Supplementary Water Management Report

Response to Contentions

Project address: Lots 1 & 2 in DP 349085 (No. 45-49) and Lot 2 in DP 972209 (No.43)

Document No.: CC230177_WMP

Figure 1: MUSIC model layout.

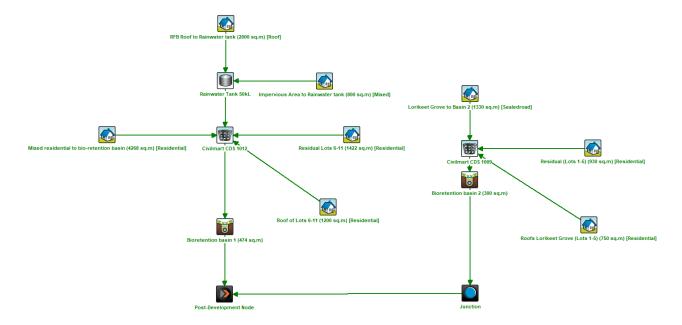
3.a.xii	The Applicant has not adequately address water quality, with over simplified and generalised statements that are not specific to the unique circumstances of the site.	A detailed MUSIC model has been prepared as part of our revised assessment. The MUSIC model can be provided to Council's representative for assessment. We can confirm that the MUSIC modelling was undertaken in accordance with Council's DCP requirements, and the pollutant reduction targets of Council's Water Management for Development Specification have been met for scenarios representing a dry, wet, and average rainfall year.

Stormwater runoff quality from the development has been assessed using a MUSIC model which considers the treatment train depicted in Figure 1. The minimum pollutant capture targets achieved are outlined in Table 2.

ROAD LONGITUDINAL SECTION (MC01) - LORIKEET GROVE Date Scale A DEC 2023 AS NOTED

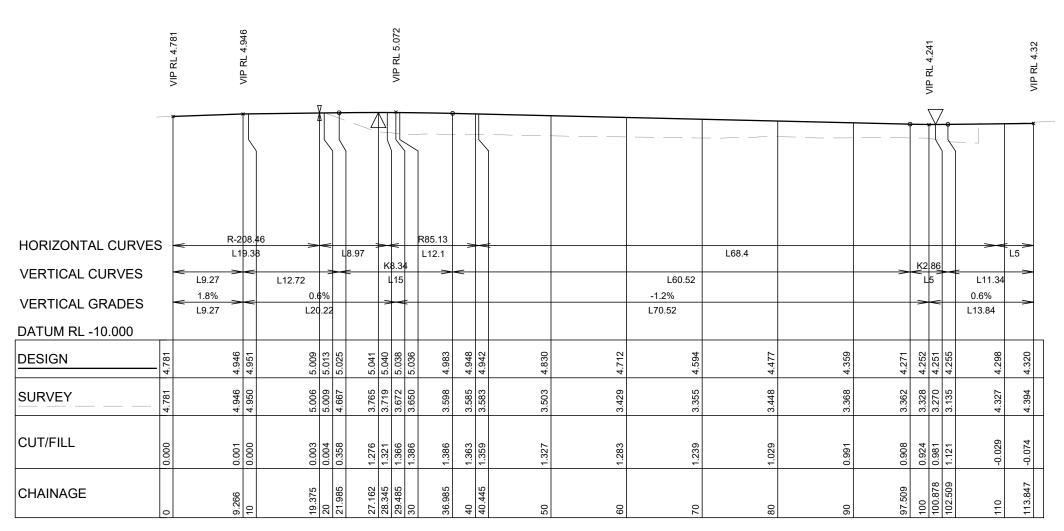
3.a.vii	The development application is not supported by sufficient long sections of stormwater lines, required to detail surface levels, the location of the pipe, the hydraulic grade line, velocities, and flows.	We refer to our revised civil engineering plans and note that a revised stormwater drainage long section has been document. The long section includes a hydraulic grade line analysis for the 100 Year ARI flows plus Climate Change.

DRAINAGE EASEMENT LONGITUDINAL SECTION (DR01) Date Scale A DEC 2023 AS NOTED

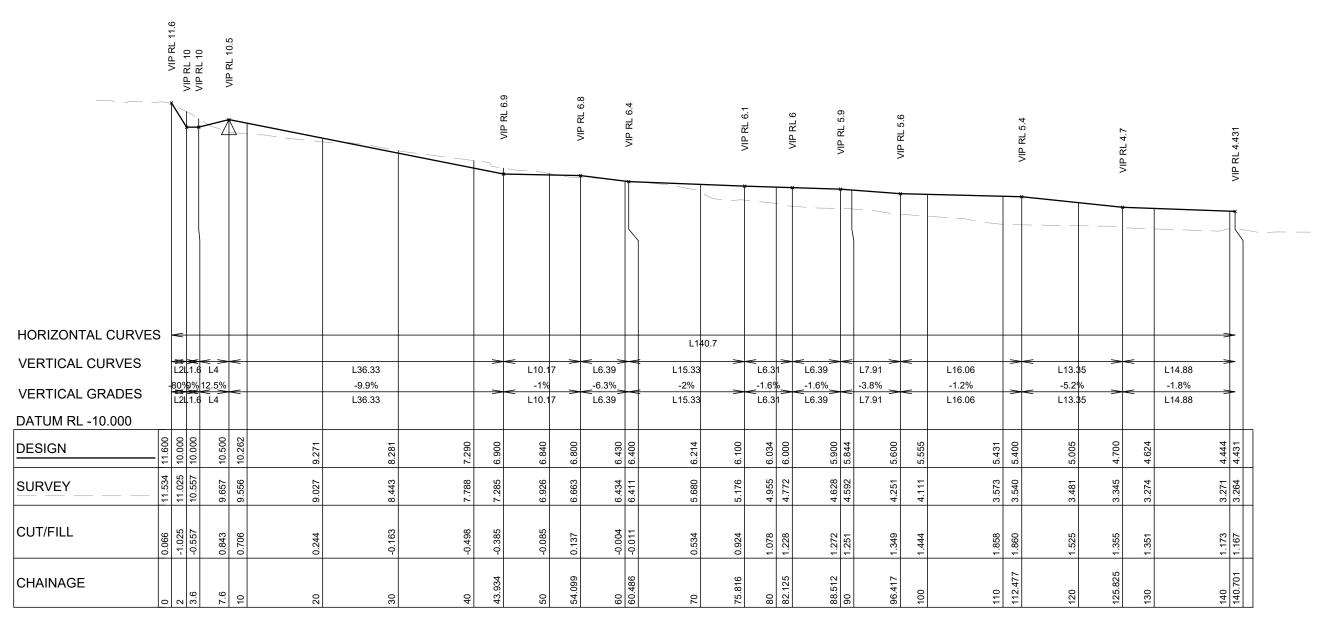
3.a.iv	The Applicant has not provided sufficient detail with respect to the design of the overland flow path over the proposed stormwater line within the existing drainage reserve. Cross sections are required along the overland flow path to detail the 1& AEP Top Water Levels and to ensure that all habitable areas are a minimum of 500mm above these levels.	We refer to our response to contention 3.a.ii and note that a revised design and associated DRAINS model has been prepared which demonstrates the system depicted on our revised civil engineering plans can sufficiently capture and convey 100 Year ARI + CC30 flows through the site.

TYPICAL DETAIL SHEET 2 OF 2 DEC 2023 AS NOTED CC230177 C3.16

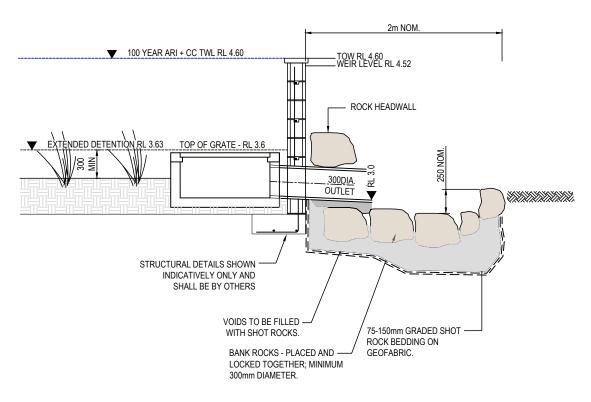
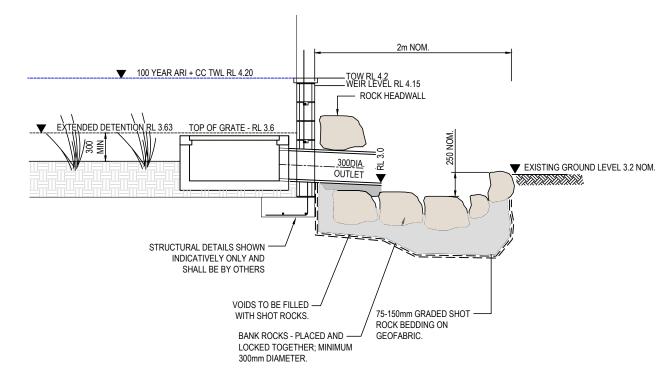
3.a.xiv	The proposed infiltration basin has a weir to control the outflow. The Applicant has not demonstrated that this is an appropriate outlet method in light of the groundwater dependent EEC along the creek line.	We refer to our document CC230177, sheets C1.00 to C3.16 (22 sheets), revision A, dated 15 December 2023 and note that weir overflows are proposed to an energy dissipation swale. This method has been discussed with Council's representatives in concept and are documented on our revised civil engineering plans. We understand this is a satisfactory outcome resulting in minimal impact to the EEC.
